LAKESHORE PARK PICNIC SHELTER JSP16-70

PLANNING REVIEW

PLAN REVIEW CENTER REPORT

Preliminary and Final Site Plan

Sheet Number: **SP-1**

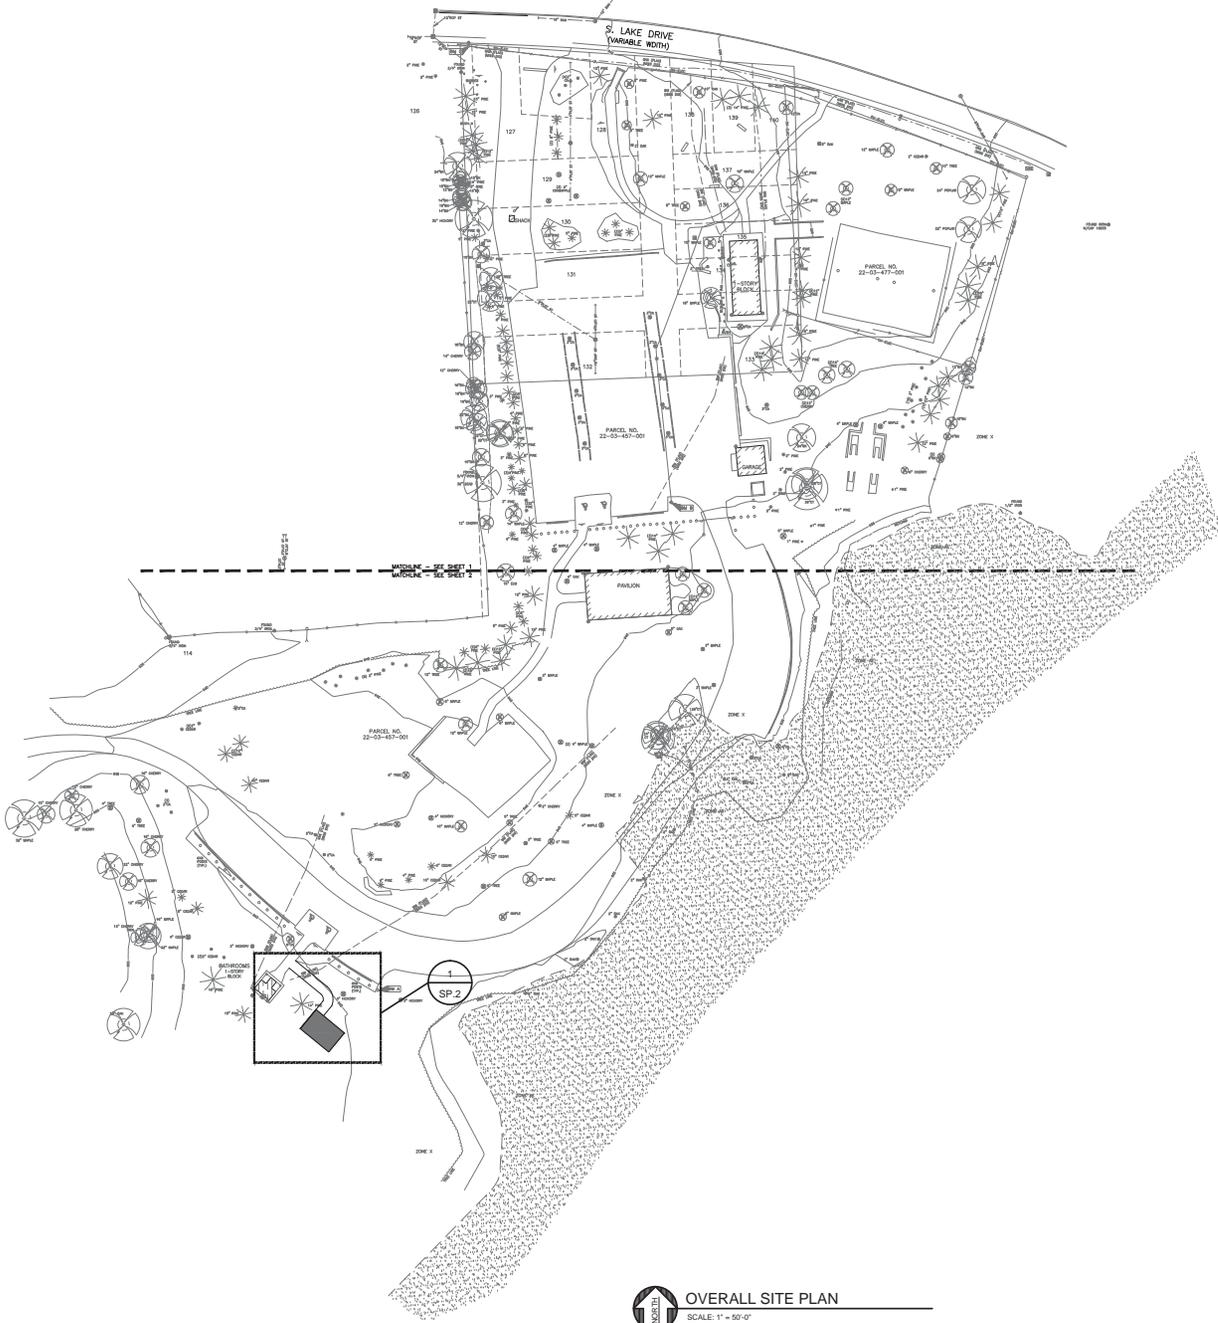
2. Revise the plan set to reference at least one city established benchmark. An interactive map of the City's established survey benchmarks can be found under the 'Map Gallery' tab on www.cityofnovi.org.
3. Plans must be signed and sealed by an engineer or architect licensed in the state of Michigan.
4. A sheet index shall be provided on the cover sheet.
5. Provide a revision data on the plans.
6. Provide a note stating the size of disturbed area.
7. Provide a note on the plans that all work shall conform to the current City of Novi standards and specifications.

Sheet Number: **SP-2**

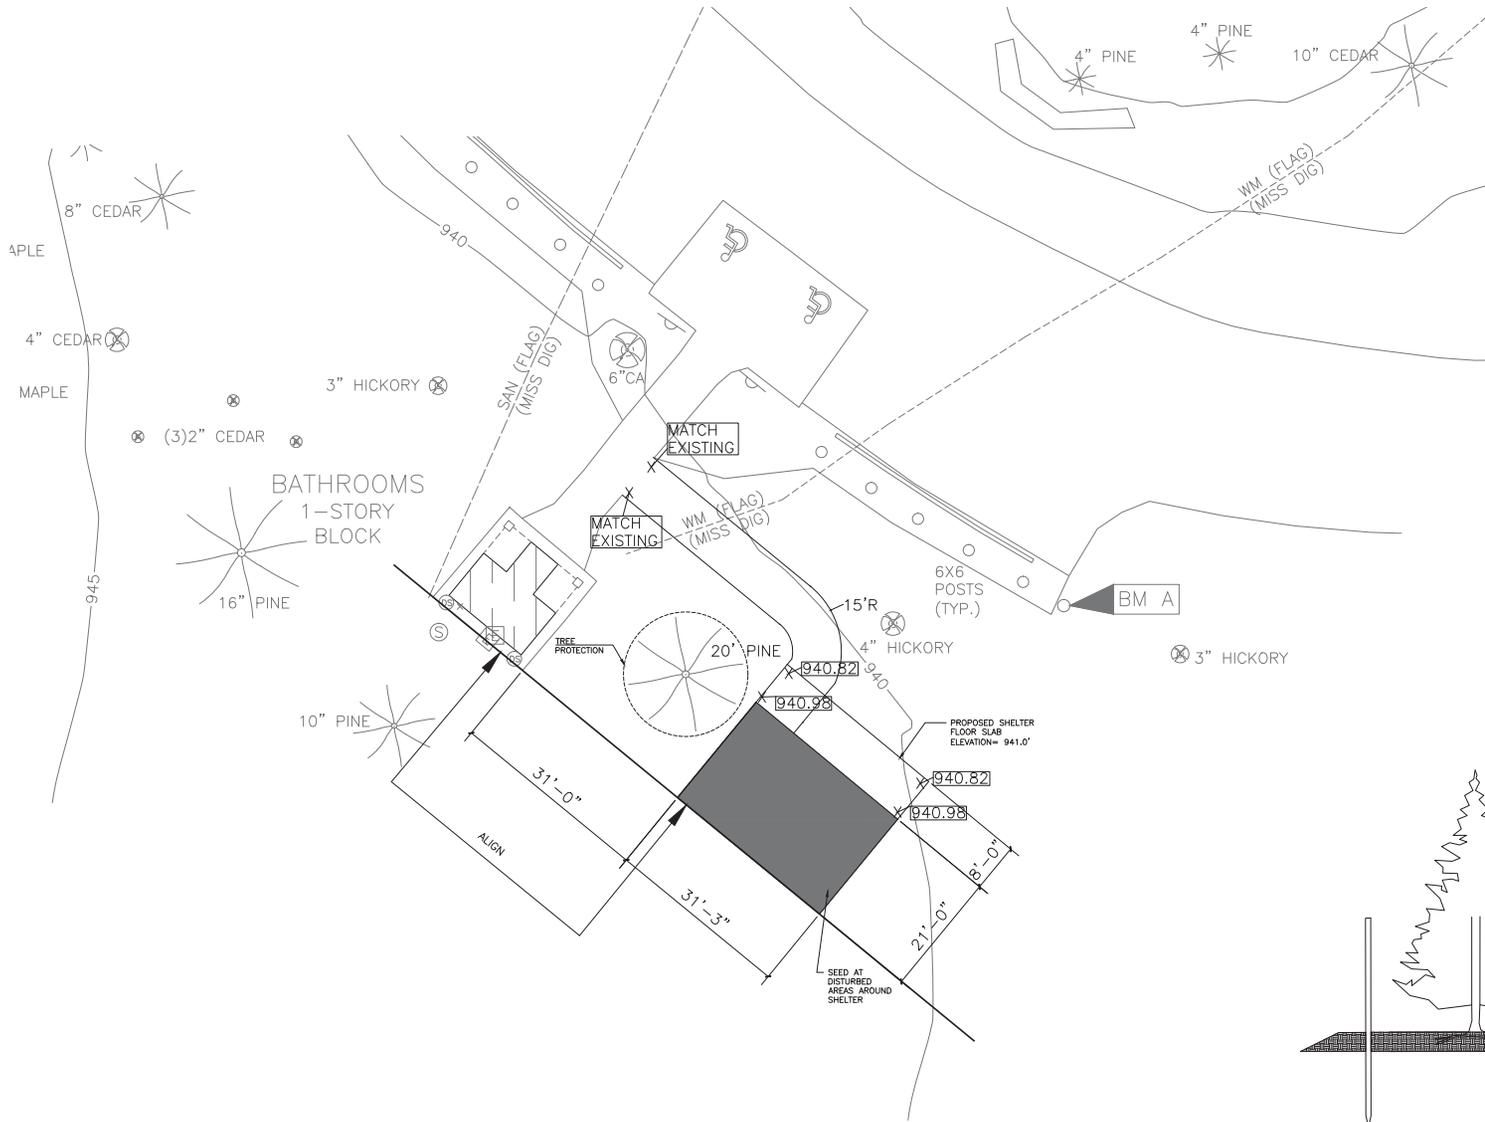
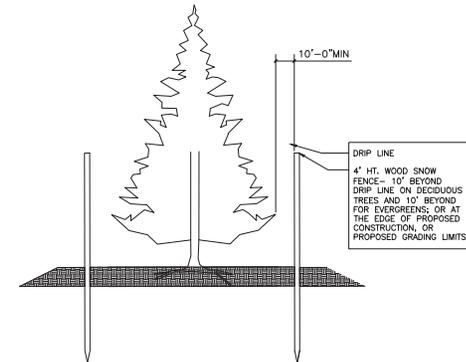
1. **Include the shelter elevation or perspective with the height indicated on sheet SP-2**

1. A tree fencing detail in the plan set showing the fencing construction and location at 1 foot outside of the dripline. The detail indicates 10 feet.
2. Indication of seed or sod to restore disturbed areas.
